ADDENDUM

December 15, 2017

RFB NO. 317028 - ADDENDUM NO. 1

SCHUMACHER BARN REMODEL/SITE IMPROVEMENTS (REBID)

2 FLOOR PLAN - PLUMBING
1/4" = 1'-0" NORTH

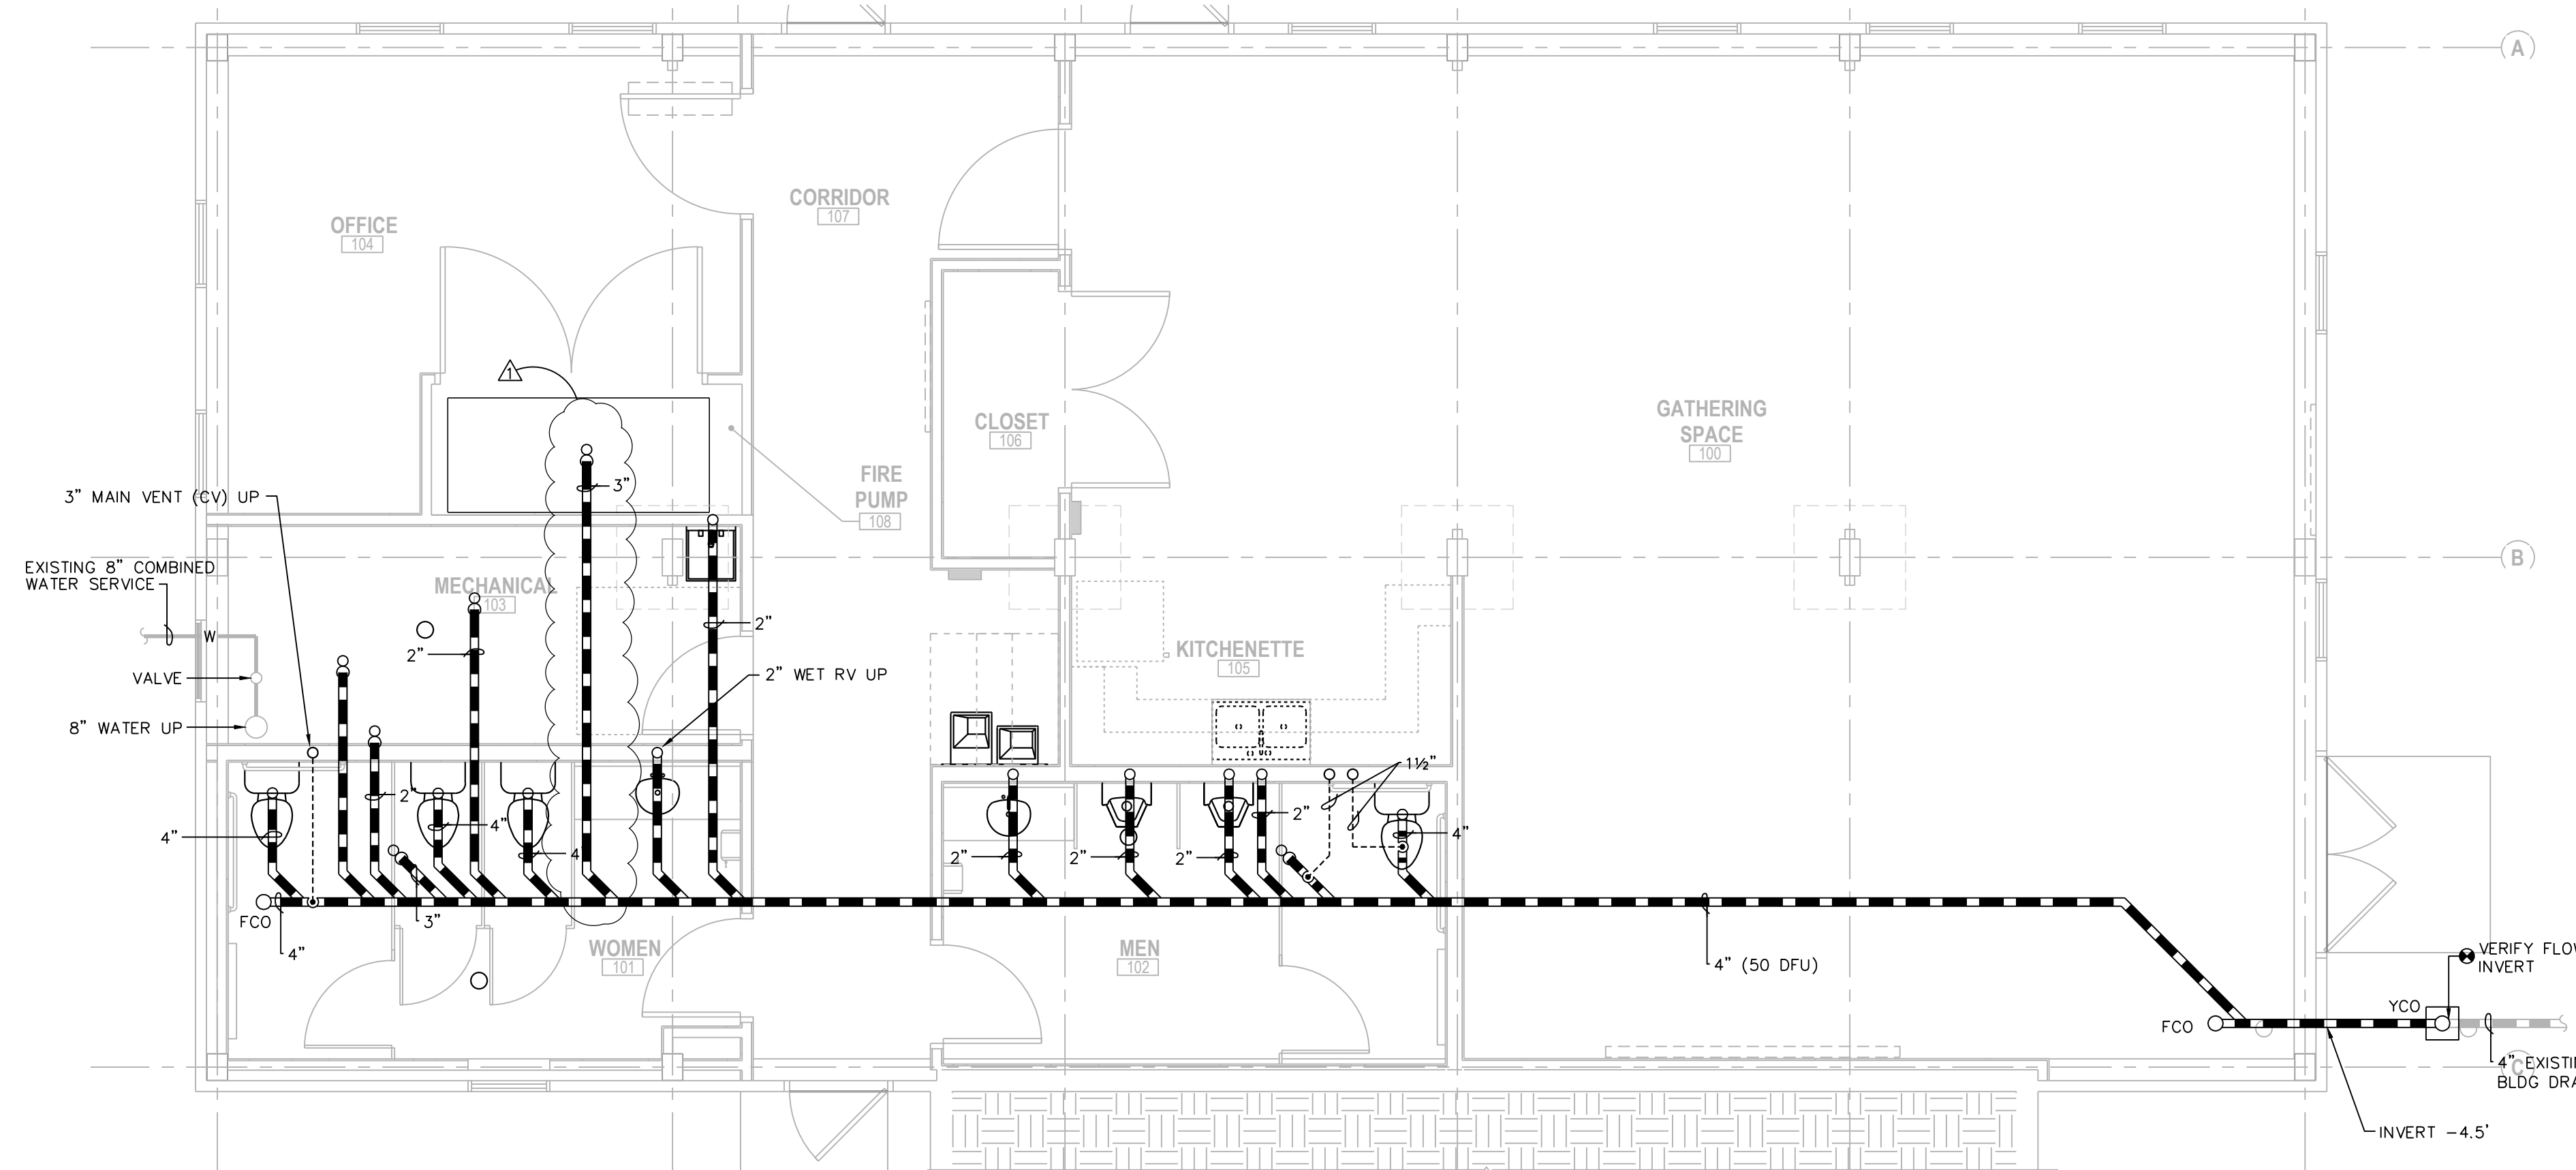
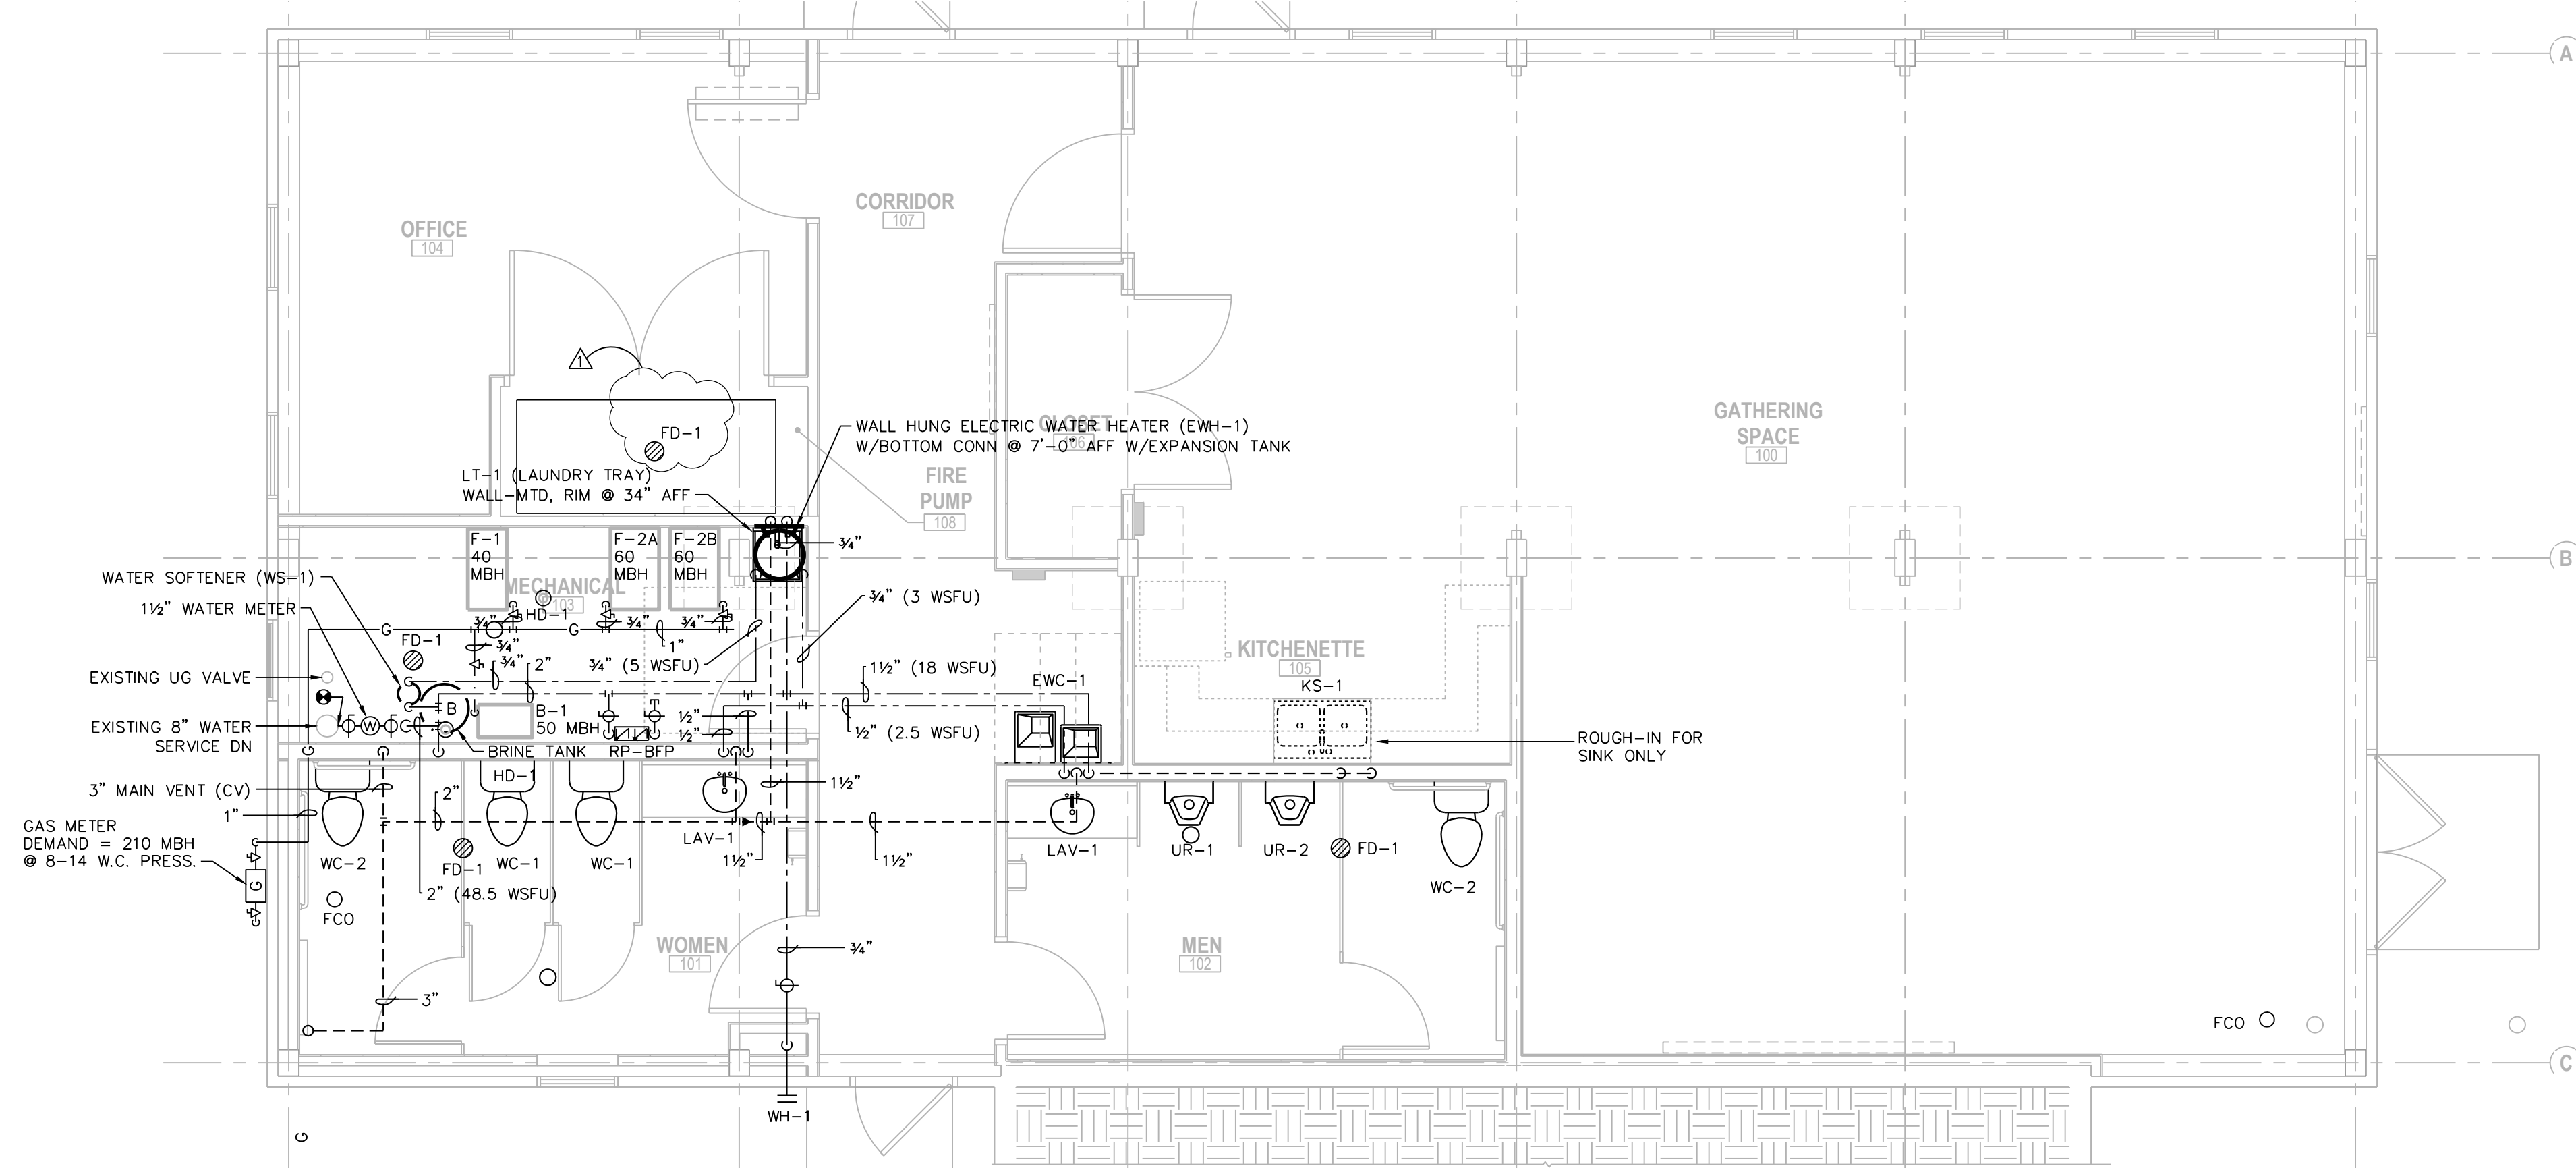
27. Sheet P1.1 - FLOOR PLANS – PLUMBING

Delete current Sheet P1.1 and replace with new Sheet P1.1, issued with this Addendum.
Added floor drain in Fire Pump 108.
